City of Portland, Oregon
Bureau of Development Services
Land Use Services

MEMORANDUM

Date: April 4, 2013
To: Jon McAuley, Sera Architects
From: Mark Walhood, City Planner
503-823-7806, mark.walhood@portlandoregon.gov
Re: 13-105388 DA – Riverplace Hyatt House
Design Advice Request Summary Memo: March 14, 2013 DAR

This memo summarizes **Design Commission** design direction provided at the March 14, 2013 DAR.

LEVEL 1 FLOOR PLAN

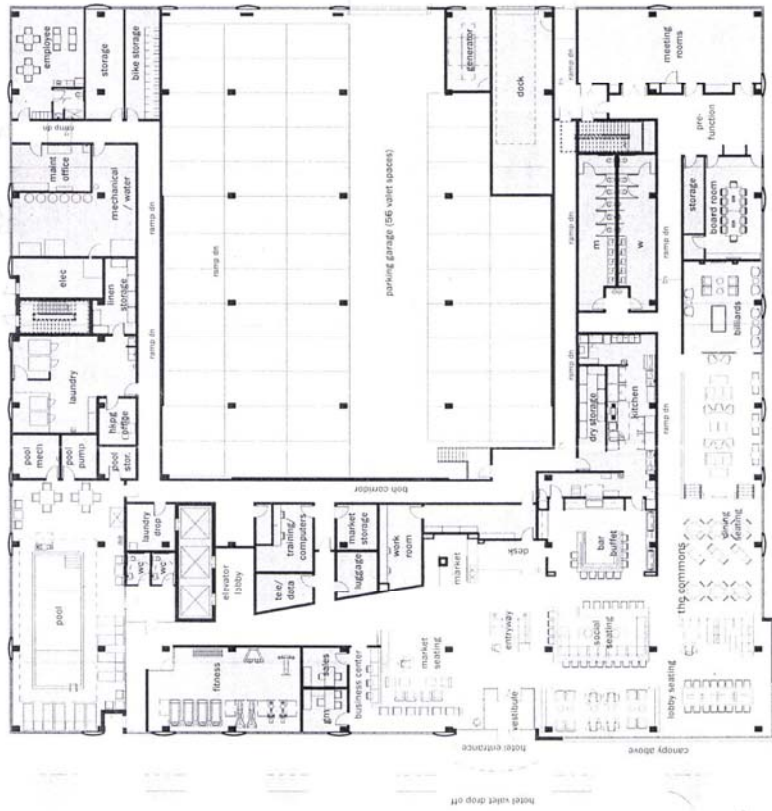
- Strong encouragement was given to provide at least a secondary entry south onto River Parkway, to facilitate direct arrival and departure of guests coming by streetcar, and to reflect the design guideline emphasis on transit accessibility.

- The main entrance feels somewhat lost, and could be more clearly identified, perhaps by better integrating it into the corner tower element. There is a counter-intuitive sense of a more closed element at grade near the tower and entry doors: could the corner tower and entry door sequence be more unified? Maybe entries from both streets have an internal axial orientation to the main reception desk? Does the doorway occur within the tower closer to the corner?

ELEVATIONS

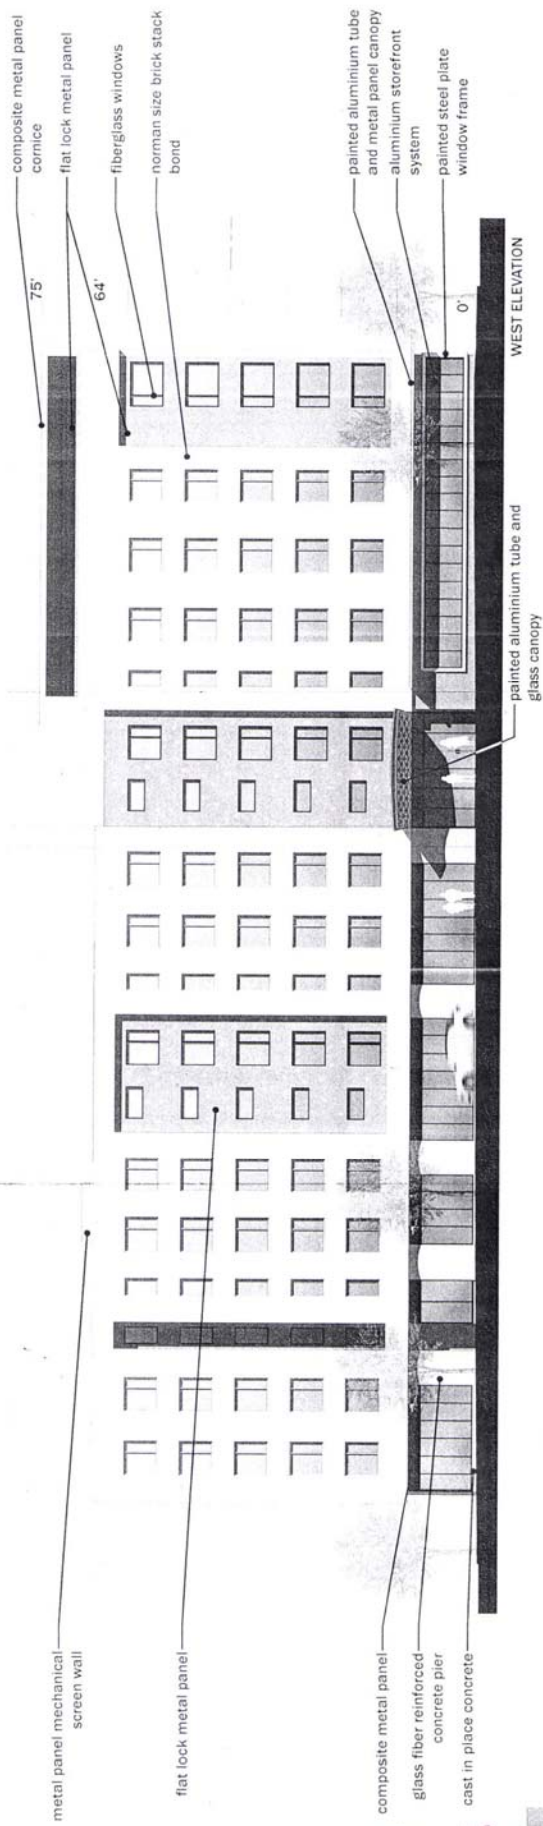
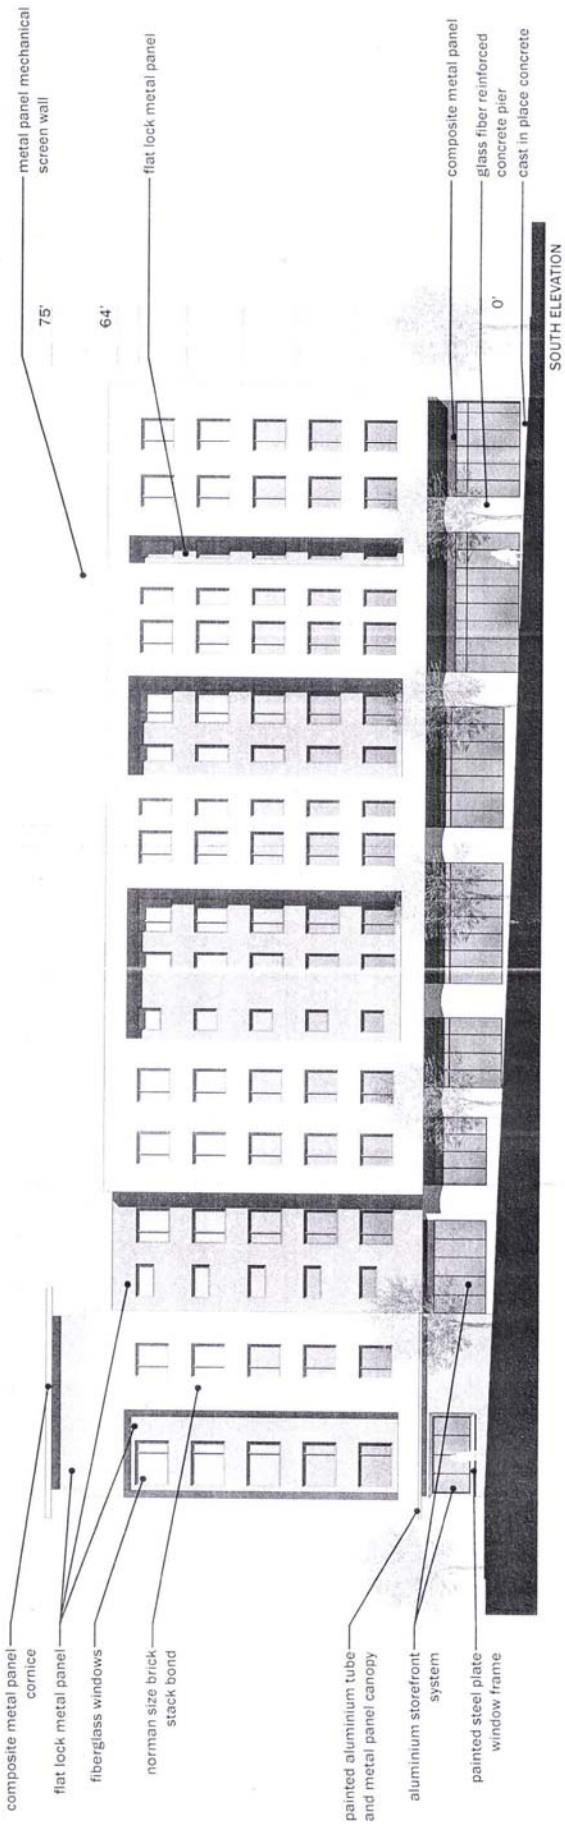
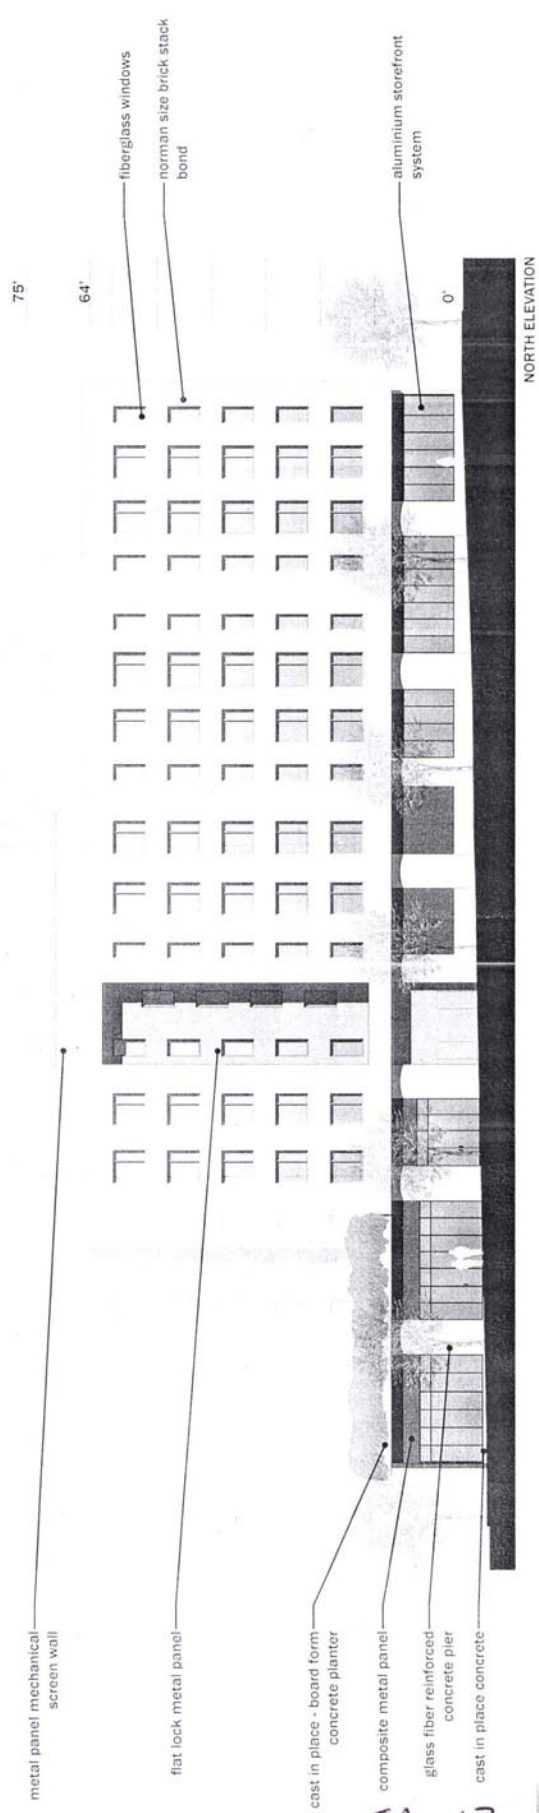
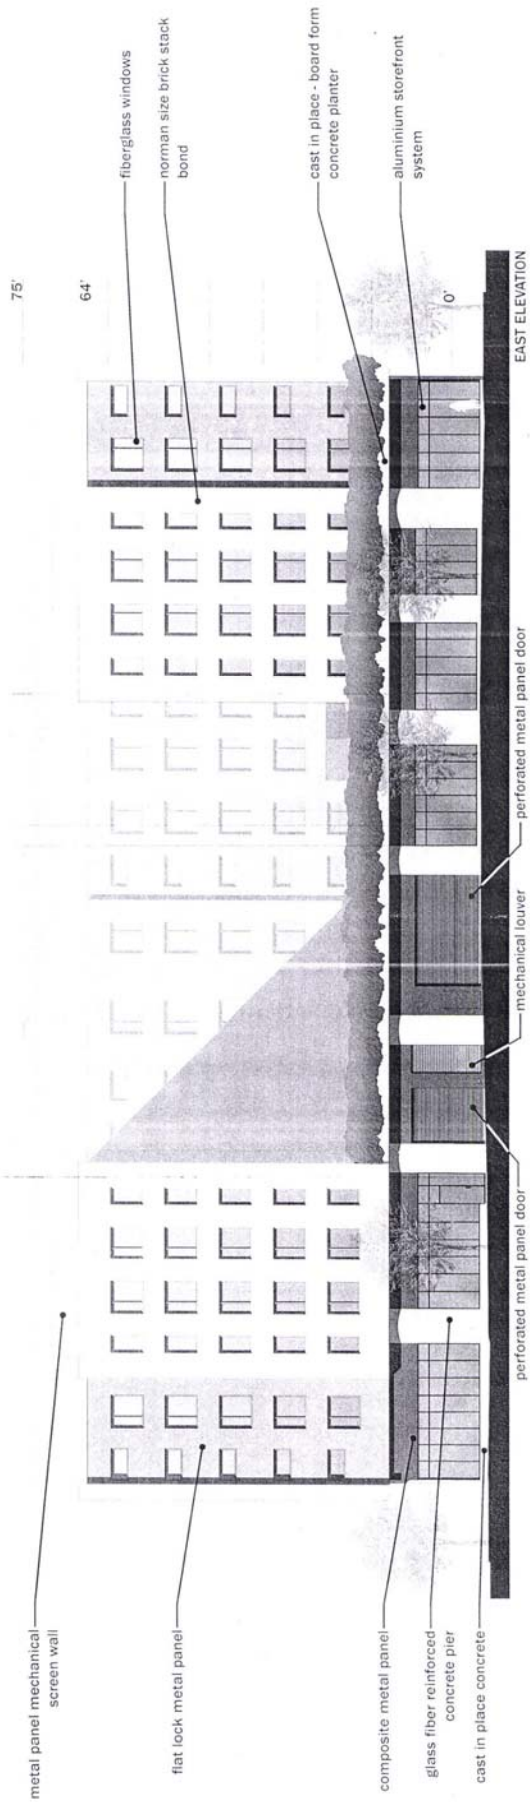
- The internal ramping along River Parkway at ground floor is appreciated, but give some thought to the awkward condition created at the east end of the façade, with the large spandrel panel/void created above the glass. The second dark metal material above the storefront glass is problematic: maybe use more fishscale in these locations?

- The round ground floor columns seem a little incongruous with the architecture, and a little bit forced. Examine that concept again, especially the relation with the building design above: the rounded design gives the feel of a different building or construction type.

- The tower as designed gives a somewhat generic, corporate feel to the building, and is an odd element that will be further weakened as an urban design element once the ubiquitous signage is attached.

- The tower element is almost 'simple to a fault' and understated. It almost feels too simple and clean, and could use further development and 'richness' – this should be an intentional design feature of the building, not just off the Hyatt design menu.

- Signage is critical to the tower. Maybe the tower works better as a single material? A stronger hat? More unified treatment of tower and base of tower along street?

- The metal landscape curtain idea is interesting. It should be integral to the overall architecture, but still feels conceptual and a little applied. Perhaps it starts closer to the corner or wraps the corner? The landscape idea feels more successful than glazing into the garage.
